LAUDERDALE CITY COUNCIL MEETING AGENDA
7:00 P.M. TUESDAY, APRIL 14, 2026
LAUDERDALE CITY HALL, 1891 WALNUT STREET

- a. Development Stage Review of Planned Unit Development Application for the Redevelopment of 2421 and 2439 Larpenteur Avenue West

From: Jennifer Haskamp, AICP
Consulting City Planner

Reference: Revised Plan Review – Holiday Stationstores, LLC – 2437 Larpenteur Ave W

SHEET NUMBER:
C040

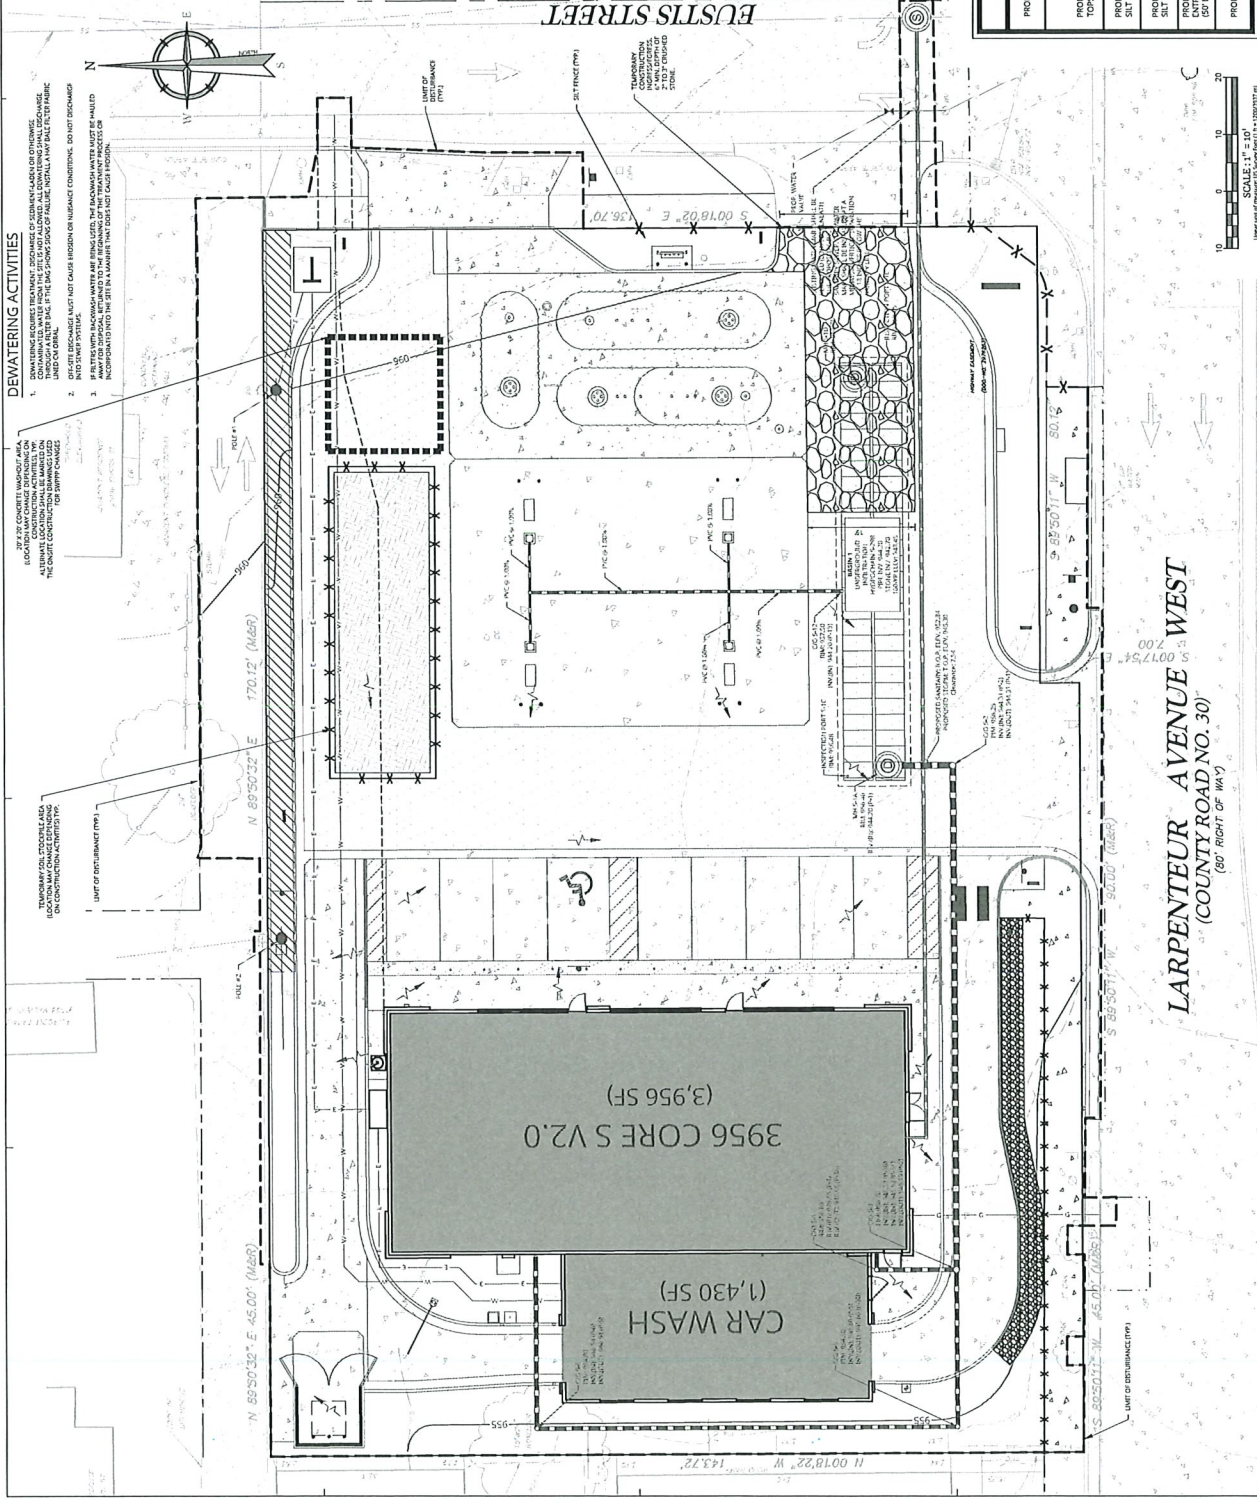
Soil Erosion & Sediment Control Plan – Sheet C040

Holiday
 HOLIDAY BRANTONKOPF, LLC
 PROJECT NUMBER: 250022833A
 SHEET TITLE: SITE LAYOUT PLAN
 SHEET NUMBER: C100

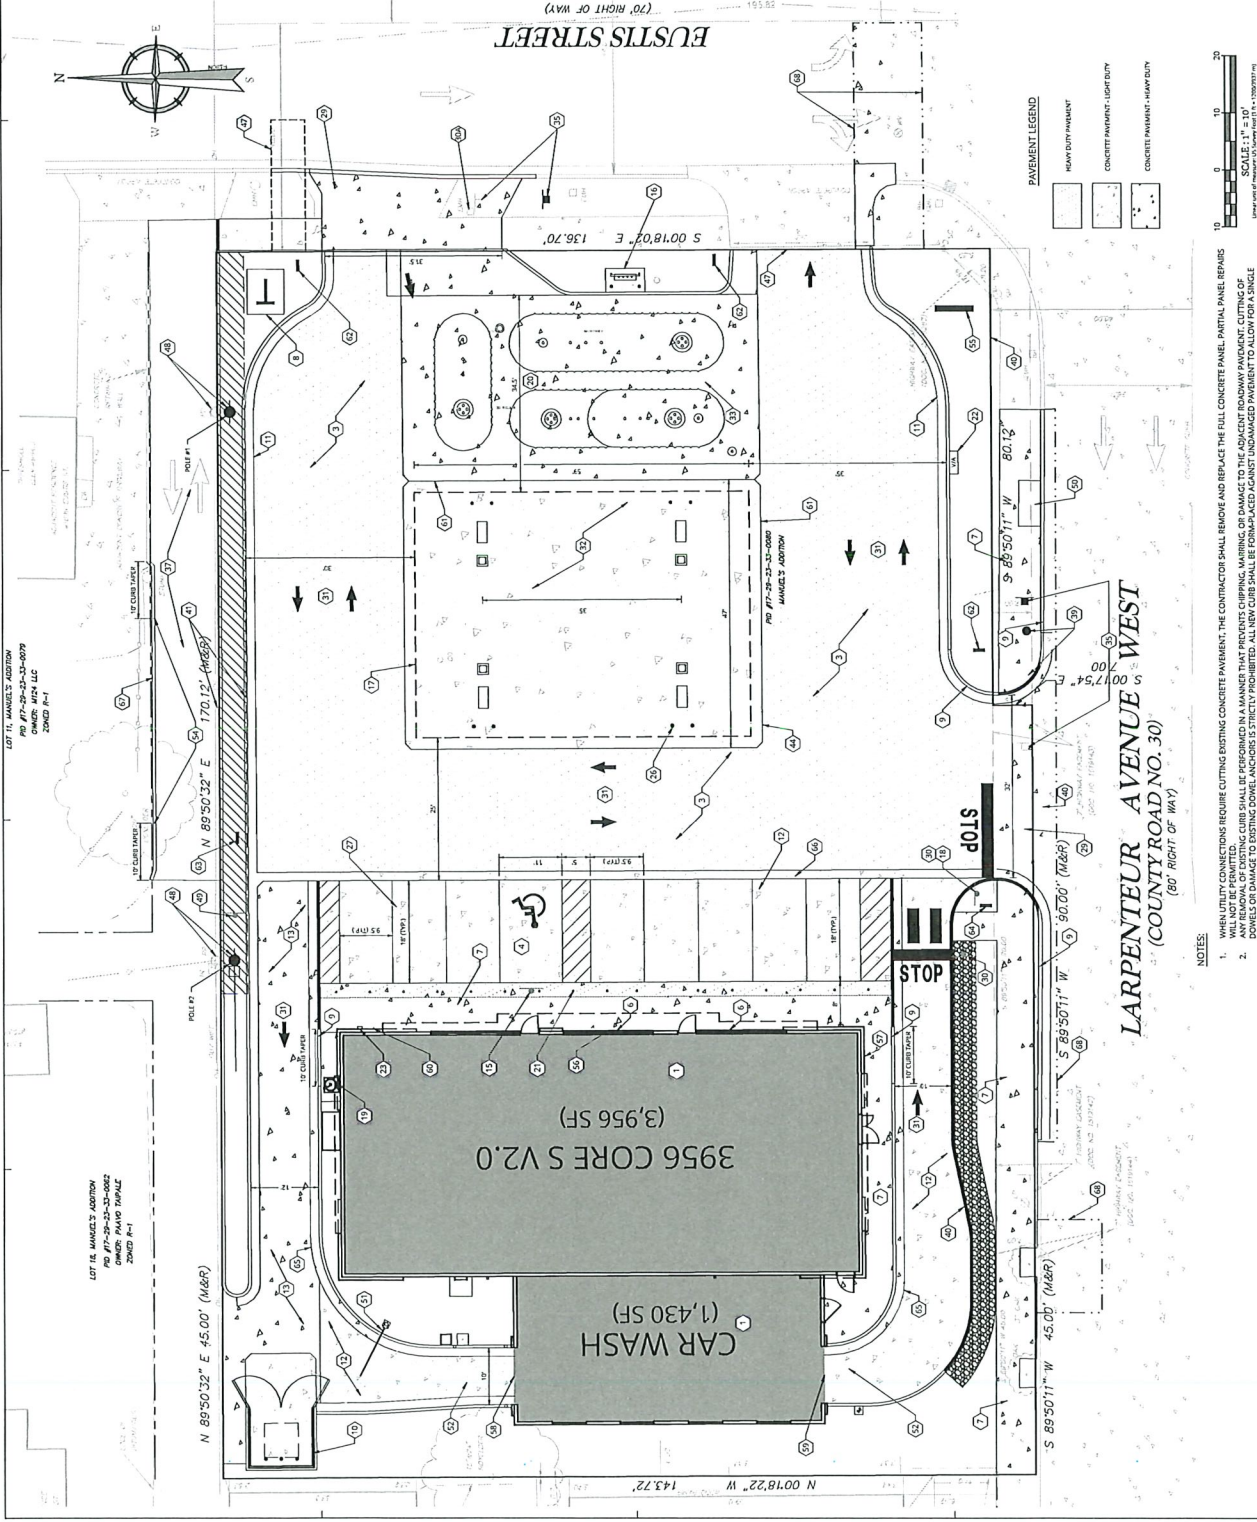
- The Applicant should provide supporting data regarding how the parking ratio of 1 parking stalls per 233 SF gross floor area was derived. The City’s ordinance does not specify number parking stalls for gas stations, however, 1 stall per 150 SF of gross floor area is required for general retail space. The proposed plan is a deviation from the parking ratio standard.

- Snow removal should be described. Based on the surface parking areas, and general site plan, there is little space internal to the site for snow removal and storage.

- Sheet C100 Site Plan includes item 54 which points to curb along the residential property to the north, but is indicated as "intentionally left blank" in the key. Please correct.

12. Dimension the proposed width of the alley.
13. Any pavement markings impacted by the proposed utility trench shall be restored to pre-project conditions.
14. There are concerns with the proposed runoff from the proposed drive around the south side of the building. The drainage will likely flow through the adjacent stone, and ultimately end up flowing over the adjacent sidewalk, potentially causing ice buildup on the sidewalk as well as unintended spillage of the drainage stone. The applicant should add a storm inlet at the low point in the access drive and route that runoff to the infiltration basin. This drainage area is not considered part of the fueling area as it is isolated by a high point in the proposed access road.

- Provide data on parking ratio based on square footage of proposed convenience store, with specific area of public retail denoted.
- Describe snow removal/storage on the site.

Holiday
 HOLIDAY STATIONERS, LLC
 PROJECT NUMBER: 25002283A
 SHEET TITLE: LIGHTING PLAN
 SHEET NUMBER: C140

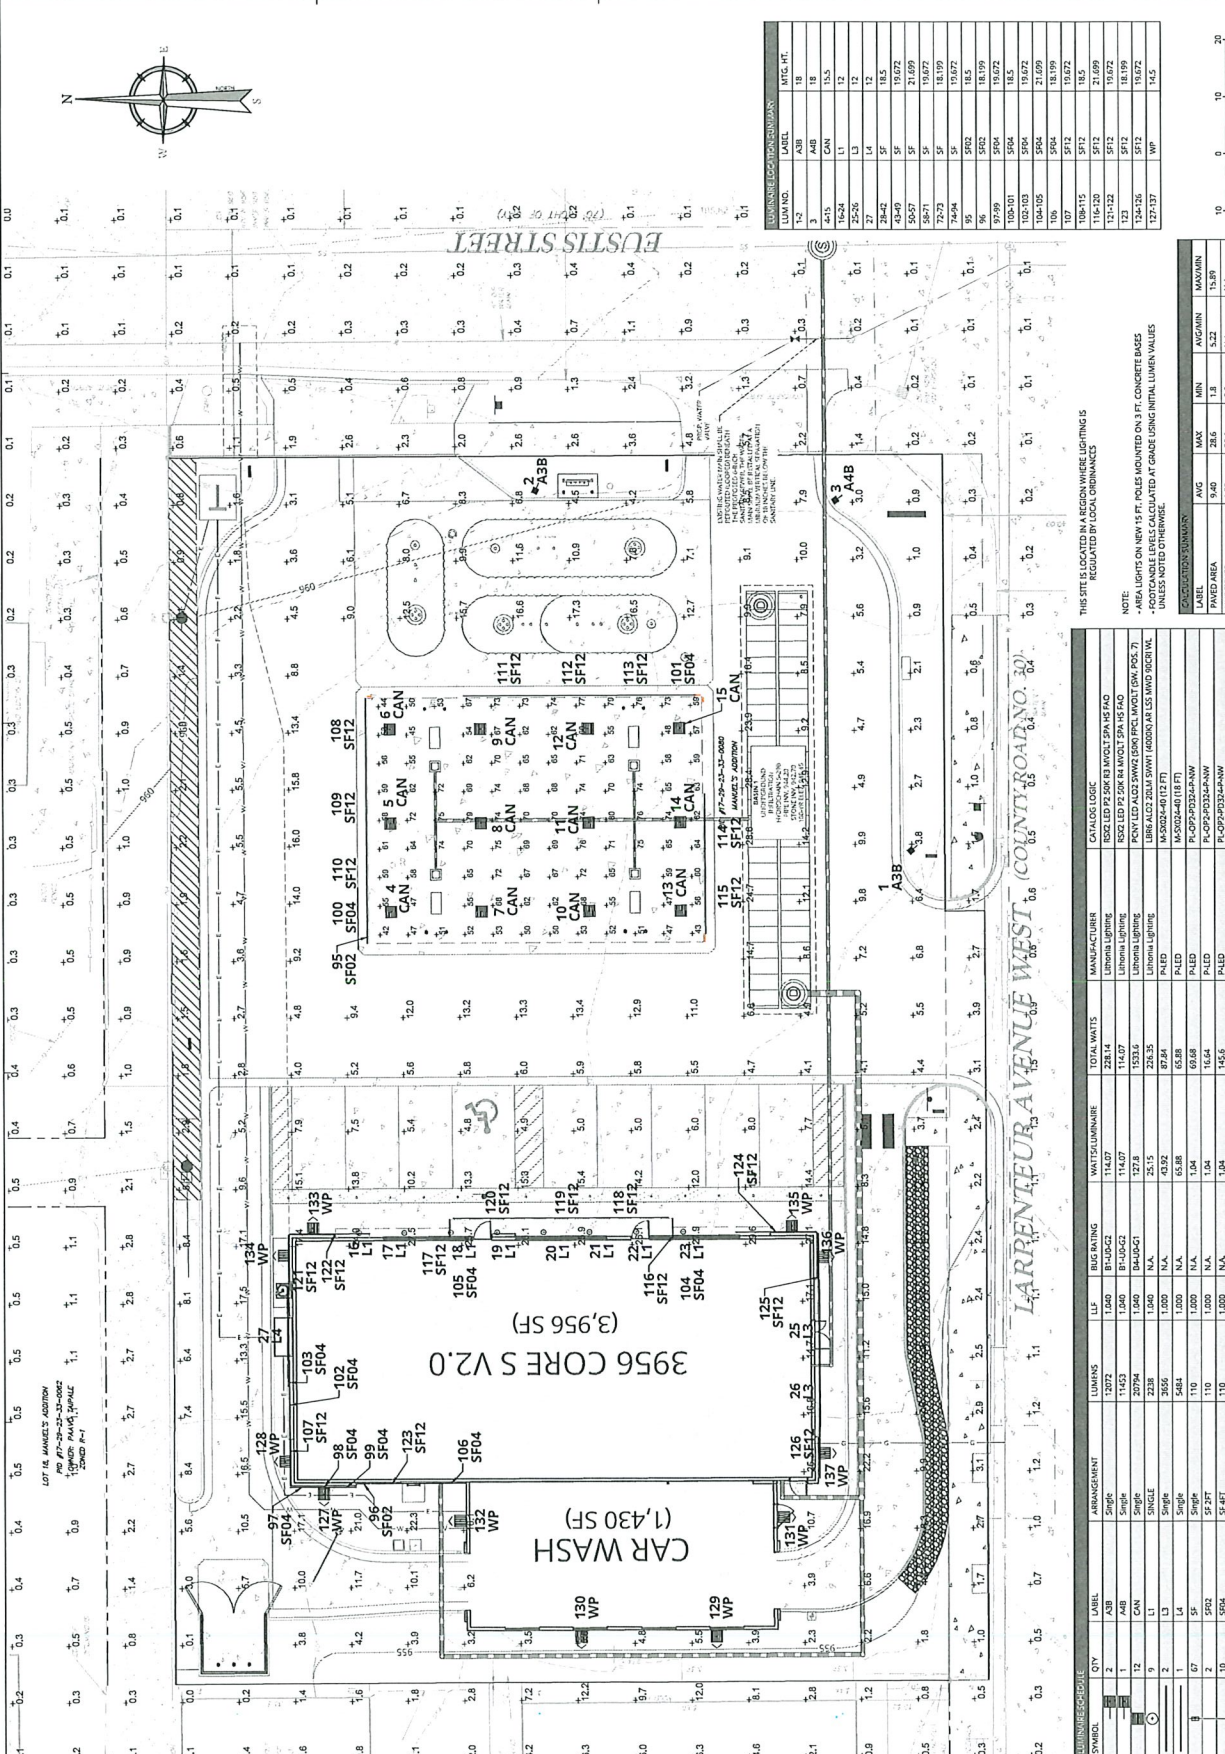
As shown on Sheet C140 Lighting Plan and C141 Lighting Details, downcast wall mounted lighting is proposed on all four sides of the building to illuminate areas of the building exterior. Nine downlights are proposed on the front/east side of the building to illuminate building entrances. Twelve canopy lights are proposed to illuminate the fueling bay. Area luminaires are proposed at the three driveway entrances from Larpenteur Avenue and Eustis Street. Tape/tube lighting is proposed on the underside of building features on the east side to illuminate the front sidewalk. Finally, LED pod modules are proposed for illuminated canopy and wall signage. The canopy side panels are proposed to have eyebrow lighting on all elevations.

- Any lighting used to illuminate the Site shall be so arranged as to reflect the light away from adjoining premises in any R district.
- All proposed internally lit signage should be accounted for and incorporated in the photometric plan. Please confirm and resubmit a revised lighting plan with the signage included in the footcandle analysis.

- Resubmit the photometric plan showing updated photometrics/footcandle analysis to demonstrate a maximum of 3.0 footcandle at all property line. Updated photometrics should also account for illuminated signage, including the monument sign.
